Proposed Development Durban Road, Bognor Regis

Stage 1 Road Safety Audit

Drawing No:	Title	Date
15/1051/04 Rev A	Proposed Site Plan	July.16

PLAN NO 615/2A
SCALES 1:100 1:200
DATE 08/07

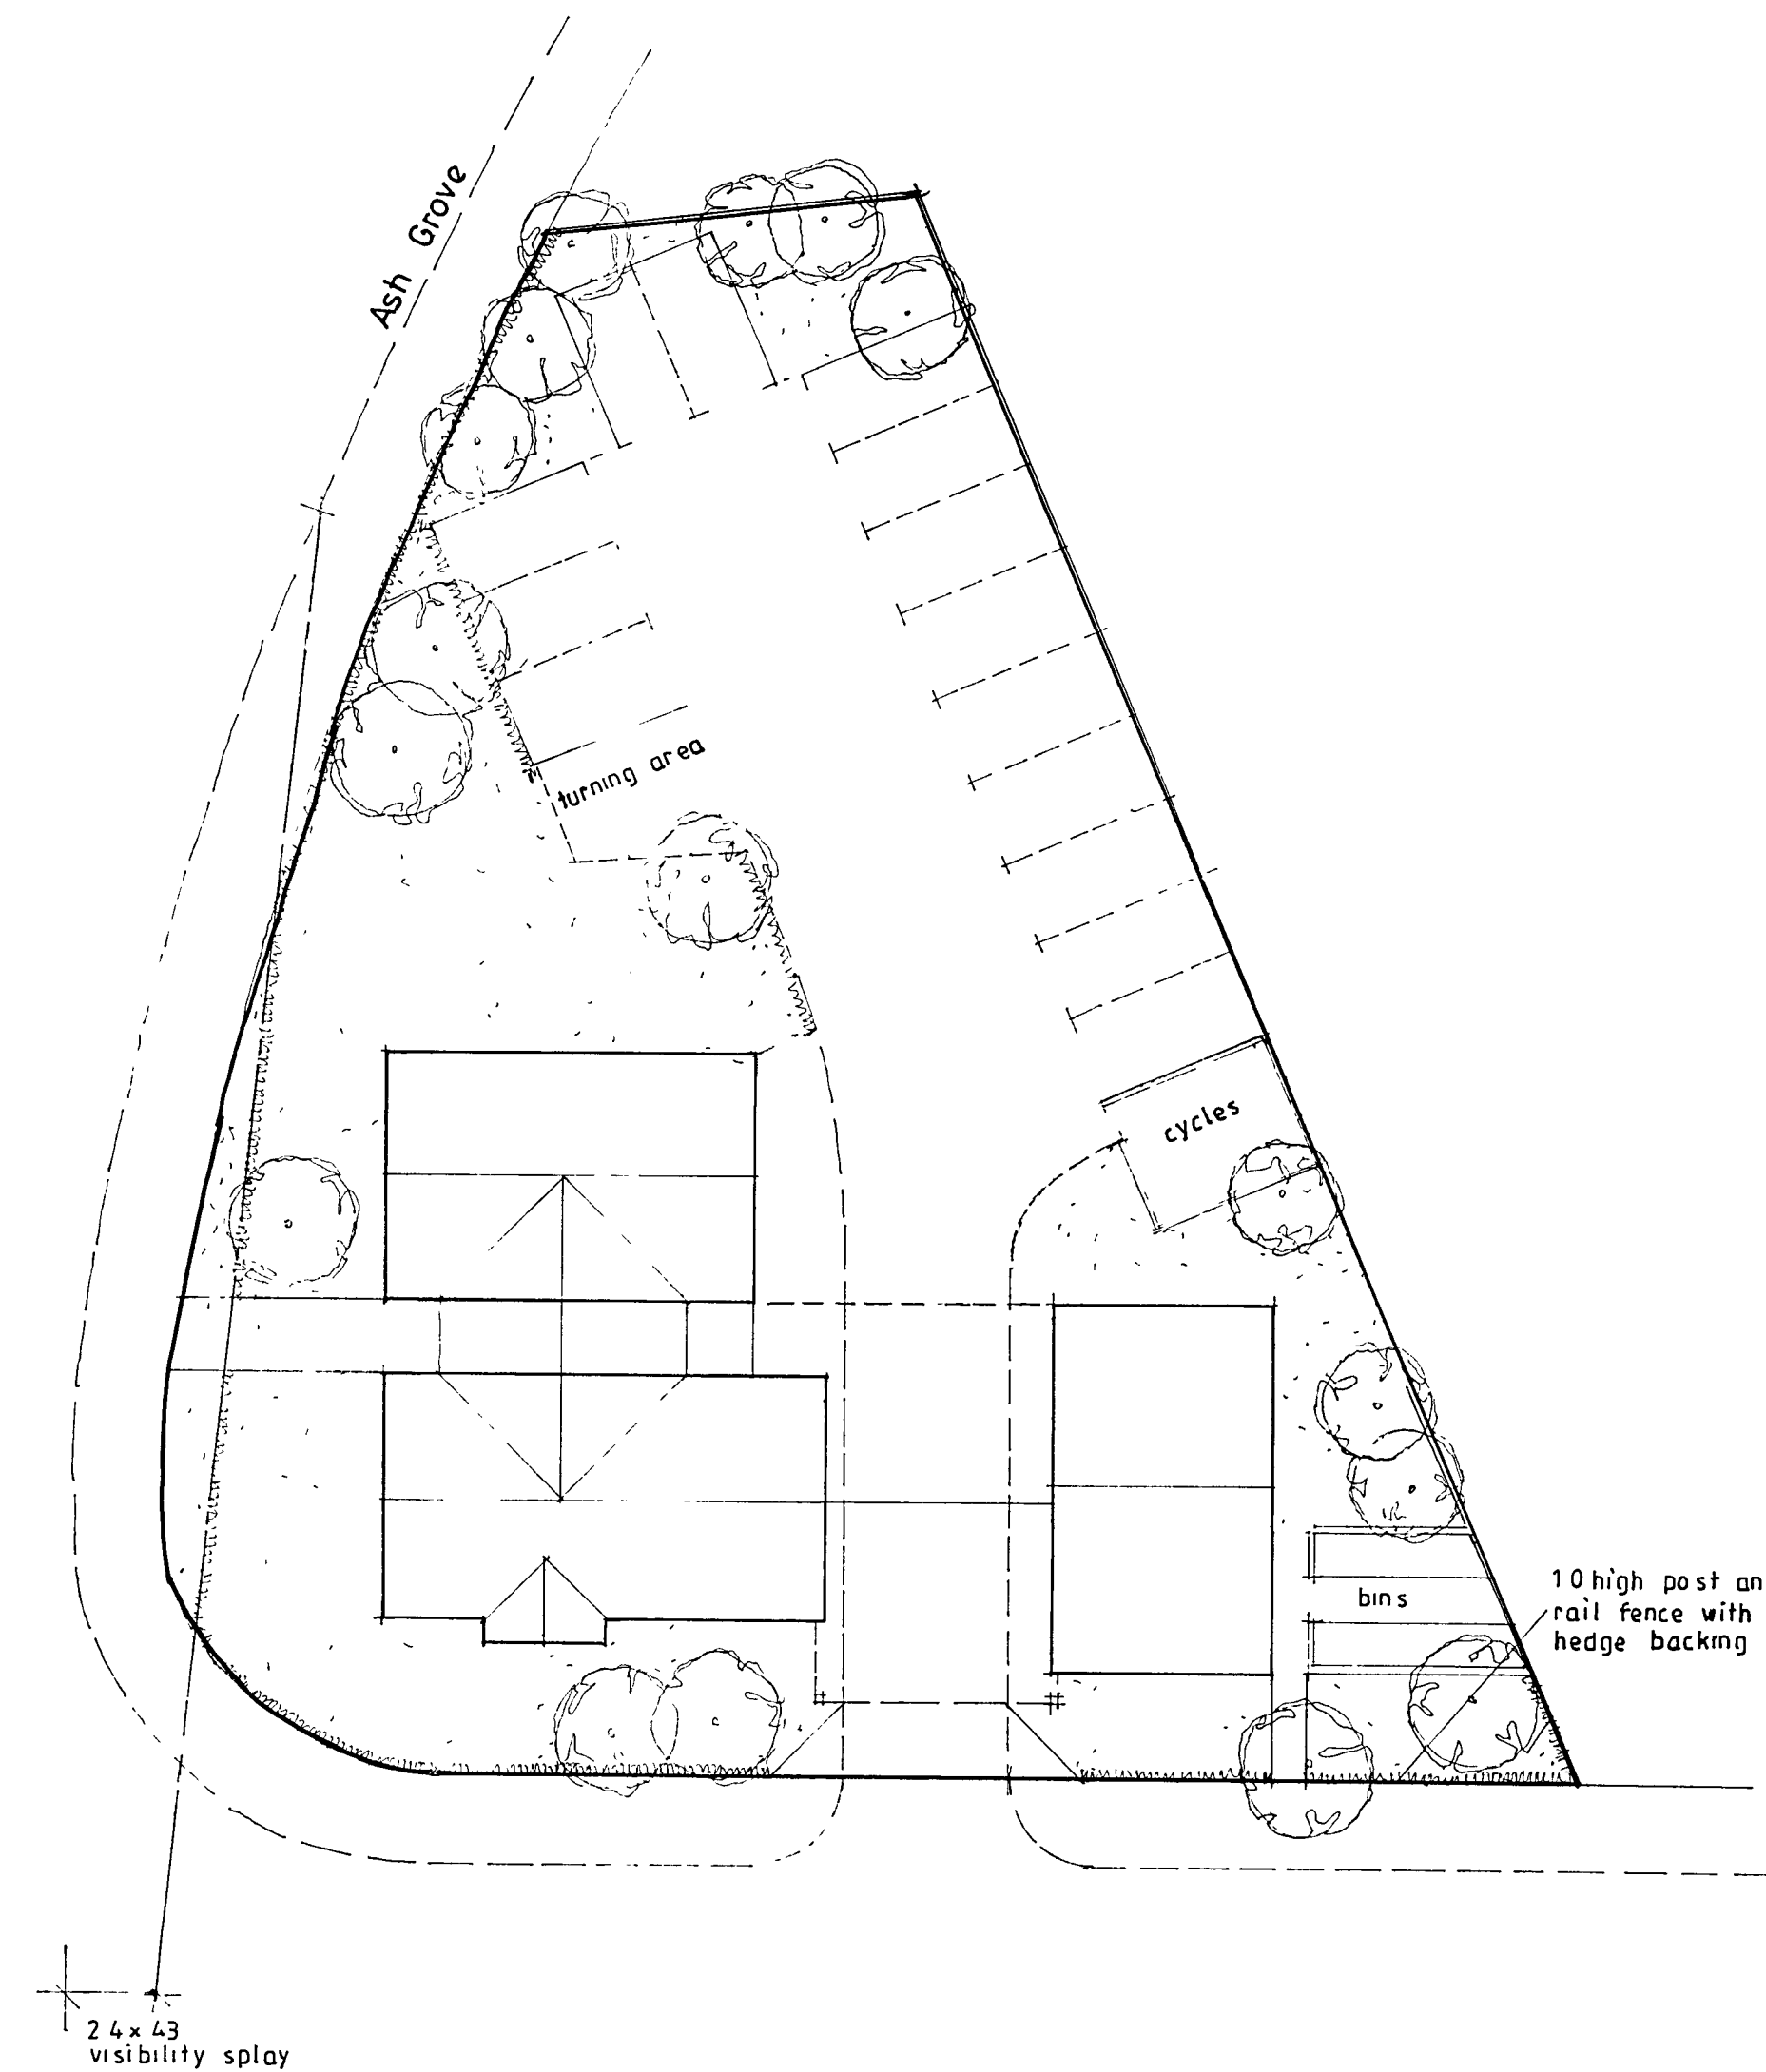
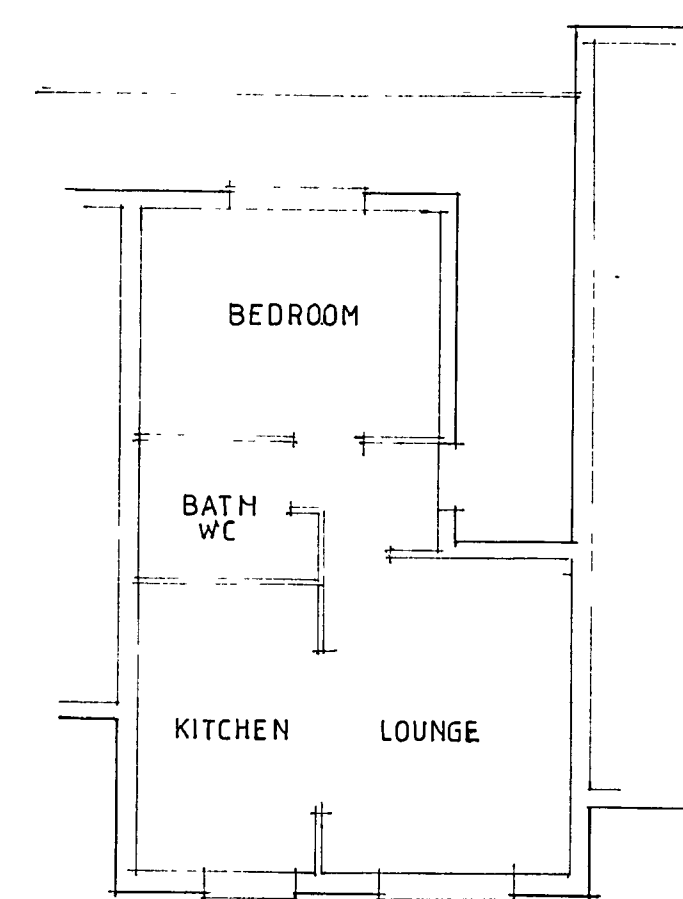
Issues Raised by Stage 1 RSA for scheme	Recommendation:
Problem A1.2: Location: Car parking area to the rear of the proposed development Summary - Risk of inadequate vehicle turning arrangements. Inadequate space appears available for vehicles to turn around and return to Durban Road in a forward gear.	A suitable vehicle turning head should be provided within the rear car park area to prevent vehicles reversing back onto the Public Highway.
Problem A3.1: Location: Durban Road, at the junction with Ash Grove Summary - Risk of inadequate visibility splay. Within the current development proposals a visibility splay of 2.4m x 43m is shown northwards across the site from Durban Road. That latter distance scales slightly less than 42m and is significantly less than the existing visibility splay currently provided across the site frontage to the northwest corner boundary of the site, giving a distance of approximately 59m to the nearside kerbline of Ash Grove. Since the current splay could also be improved with removal of the lower growth of the tree at the northern corner of the site boundary, concern arises that the indicated splay is likely to be inadequate for the curved carriageway alignment and may increase the risk of conflict at the existing junction. Although the WSCC correspondence indicates the visibility distance should be supported by Speed Survey results, none were available for this audit.	The proposed visibility splay of 2.4m x 43m associated with this development should be revisited in the light of current provisions and a risk of worsening current conditions, whilst proposed car parking; spaces within the existing visibility splay could be rearranged closer to the buildings and growth of lower branches of trees at the northwest corner of site could be trimmed back. The visibility splay should be restricted to grass verge only by covenant or planning conditions.

Problem A3.2: Location: Site access, at the junction with Durban Road Summary - Risk of vehicles obstructing inter-visibility. At the time of the site inspection, vehicles were parked on the north side of Durban Road at the east side of the existing site access. Consequently, drivers emerging from the site access point may not be clearly able to see oncoming westbound vehicles and conflict may result.	To provide a clear visibility splay eastwards from the site access, waiting restrictions may need to be investigated along the north side of Durban Road.

Issues Raised by Stage 1 RSA for scheme	Recommendation:
Problem A3.3: Location: Site access, at the junction with Durban Road Summary - Risk of inadequate safety at the site access. The development proposals appear to retain the existing site access which is a combination of a vehicle crossover and bellmouth construction, resulting in high kerb upstands and dropper kerbs across the footway. Consequently, as the type of access to the site is not clear, footway users may be endangered by the current arrangement. In addition, the width of the pedestrian pathway along the east side of the access road appears to be inadequate, especially as along that pathway a doorway appears to be provided into the ground floor unit.	The site access road, its pedestrian access from Durban Road and its junction with the existing footway and carriageway of Durban Road should be revisited to clearly indicate safer proposals.

Problem A4.1: Location: Durban Road, at the east side of the proposed building Summary - Risk of inadequate access to the cycle and bin stores. No footpath link is shown from Durban Road. into the cycle and bin stores, whilst the gap between the building walls appears to only scale 1.0m width which is likely to be inadequate for cyclists to safely gain access to the store.	Access between Durban Road and the cycle and bin stores should be reviewed and provision of a suitable width footpath link to Durban Road should be investigated.

Stage 1 RSA	Design Team response.
Problem A1.2: Location: Car parking area to the rear of the proposed development Summary - Risk of inadequate vehicle turning arrangements.	A vehicle turning area is now shown in the car parking area
Problem A3.1: Location: Durban Road, at the junction with Ash Grove Summary - Risk of inadequate visibility splay.	The visibility splay of 2.4m x 43m at the junction of Durban Road with Ash Grove is in accordance with the standards set out in "Manual for Streets", for a junction of this type within an area subject to the 30mph speed limit. In practice the visibility attainable is greater than the required minimum, as is apparent from the drawing, and is substantially greater than the achievable visibility in the opposite direction. In the circumstances it is not considered that any amendment to the scheme is required. <i>WSCC Highways response (Dec 2007): A3.1 refers to the provision of a 2.4 x 43m visibility splay to the north at the junction of Durban Road and Ash Grove. This splay is required to be protected as at present the site is open plan and visibility cuts across the site. Due to the open plan nature visibility does exceed 43metres at present, consequently the enclosure of the land would result in a lesser visibility splay than exists presently. However, the 43metre splay does meet with current standards for a 30mph road, it would therefore be unreasonable to request a longer splay. The boundary treatment as shown on the submitted drawings do also take into consideration this splay and given the integral importance of the splay to highway safety, I consider that the area of land within the splay should be dedicated as highway under a S38 Agreement.</i>

Problem A3.2: Location: Site access, at the junction with Durban Road Summary - Risk of vehicles obstructing inter-visibility.	While there may be a small risk of parked vehicles obstructing visibility at the access point, the proposal will not make the present situation any worse. Any such vehicles are on the public highway and therefore not in the control of the applicant. If the highway authority consider that a serious problem may exist, it is open to them to investigate possible parking restrictions. <i>WSCC Highways response (Dec 2007): Point A3.2 refers to the obstruction of visibility at the existing access by cars parked along Durban Road. I do note that the access is existing and serves an existing, albeit it redundant use. Consequently, I do not consider the provision of waiting restrictions to be a definite requirement to permit this development to take place.</i>

Stage 1 RSA	Design Team response.
Problem A3.3: Location: Site access, at the junction with Durban Road Summary - Risk of inadequate safety at the site access.	The details of the access have been modified to reflect the recommendation
Problem A4.1: Location: Durban Road, at the east side of the proposed building Summary - Risk of inadequate access to the cycle and bin stores.	The details of the cycle store and the refuse store have been modified to reflect the recommendation
